Board of Adjustment

VARIANCE REQUESTS FOR THE PROPERTY AT 6 LADUE MEADOWS TO ALLOW FOR ADDITIONS TO THE HOME TO PROJECT UP TO 15 FEET INTO THE REAR-YARD WHERE THE REQUIRED REAR YARD IS 30 FEET

REPORT PREPARED BY: Whitney Kelly, AICP, City Planner
DATE: 5-11-2017
ATTACHMENTS: Applicant's Materials submitted April 14, 2017
Public Comments Received

Re: Broughton Residence
6 Ladue Meadows
Creve Coeur, MO 63141

Figure 1: Close-up of the existing site plan.

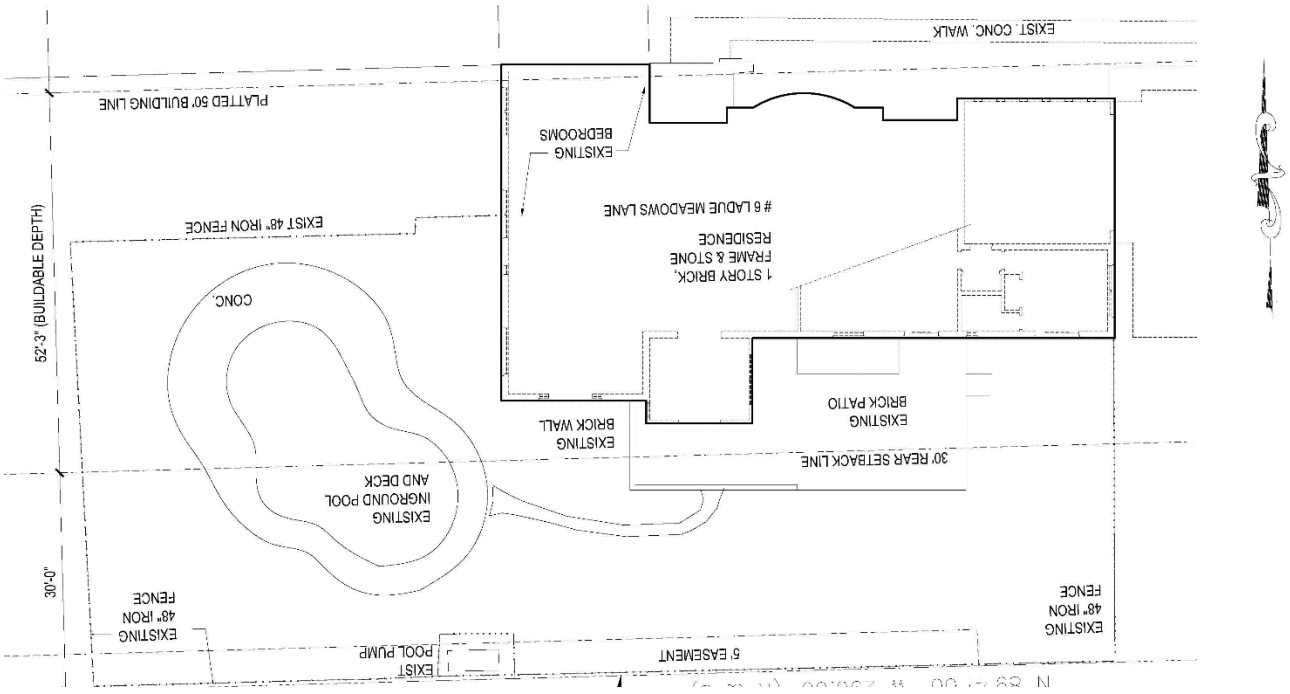
As stated in the attached application materials, the Applicant's basis for requesting the variance is a desire to build an addition and outdoor patio consistent in the style of the existing home. While the recorded plat indicates that the lot depth is 157.24 feet, and the lot width is 300 feet, when Ladue Meadows was made a public road, this resulted in the lot depth of 132 feet 3 inches. Due to the orientation of the existing home toward Ladue Meadows, Staff determined that the rear yard of 30 feet for the A Single Family District should apply. With this, and the corner lot configuration of a front yard setback of 50 feet along Ladue Meadows, and 75 feet along Mosley Road, the buildable area of the property is limited and hampers the applicant from being able to fully realize the proposed addition. Therefore, the Applicant is seeking approval to allow a one story addition to project 14 feet, 6 inches into the rear yard setback, and an outdoor covered patio to project 14 feet, 6 inches into the rear yard setback.

While, the non-conformity of the lot dimensions is the result from the actions prior to the current Applicant, it is the Applicant's decision to place the addition and patio within the setback. However, the homeowner desires to maintain the single story, original character of the home. It is possible that the addition could be redesigned to fit within the buildable area, or a second story and/or detached accessory structures may be included in conformance with the Zoning Code. Thus, the placement of the additions within the rear-yard setback, in-order to maintain a single story ranch style home is solely the decision of the Applicant. It is the applicant's decision to create an addition to the home that creates the need for a variance.

Figure 2: Close-up of the proposed site development plan.

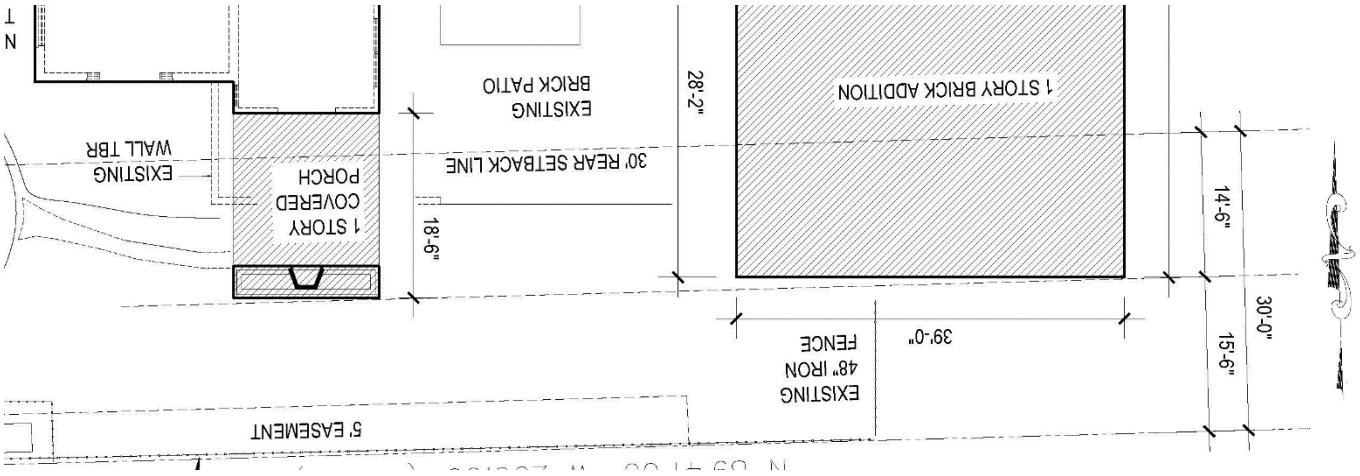
The improvements decrease the rear-yard setback by half of the property which is a significant amount, but, whether or not this enlargement represents an adverse impact upon adjacent property owners or residents is fairly debatable. The closest resident to the south has indicated an objection to an extension of the home.

No evidence has been submitted that suggests that the property is so adversely affected by the zoning district regulations that they will cause an extreme hardship. It is the Applicant's decision to seek approval of the additions at approximately 15 feet from the rear property line, instead of maintaining the 30 foot setback. While the existing pool on the west portion of the lawn may be an obstacle and an amenity to the home that any resident may wish to maintain, it is fairly debatable that it represents an extreme hardship. While maintaining the character of the existing home is often cited as a goal of residents, the trend is often to do a teardown and rebuild. When completing additions, the option available is to the rear of the property. The Applicants wish to include a new three car garage, and in-law suit, and workshop area to a large degree requires them to obtain the variance. The inability to fully implement the design does not provide an extreme hardship for the property. If some of the elements were reduced, or eliminated the variance request could be reduced, or unnecessary altogether.
